10 Mb/s Single Twisted Pair Ethernet PCS Receive State Diagram

Steffen Graber
Pepperl+Fuchs

PCS Receive State Diagram

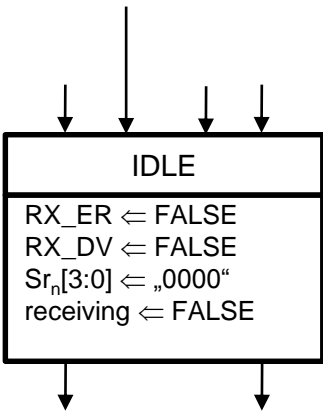
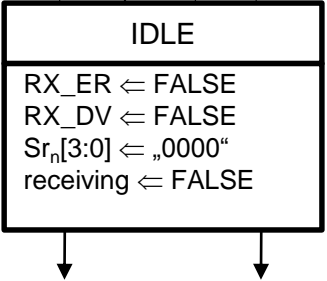
- An additional state (“WAIT SCRAMBLER”) for descrambler synchronization is required for the state machine to wait until the descrambler is in sync before going into "IDLE" state:
 - Otherwise in case the descrambler is not synchronized, it is possible that the state machine hangs in "BAD DELIMITER" state until jabber is detected and the state machine is resetted.
 - Then the state machine is in “IDLE” state again, but not receiving valid idle data as the descrambler is not synchronized.
 - In this case the state machine jumps from the "IDLE" state into "BAD DELIMITER" state again without syncing the descrambler, thus ending up in an endless loop.

Add additional
 „WAIT SCRAMBLER“
 state in PCS receive
 state diagram.

RSTCD * (scr_status = OK)
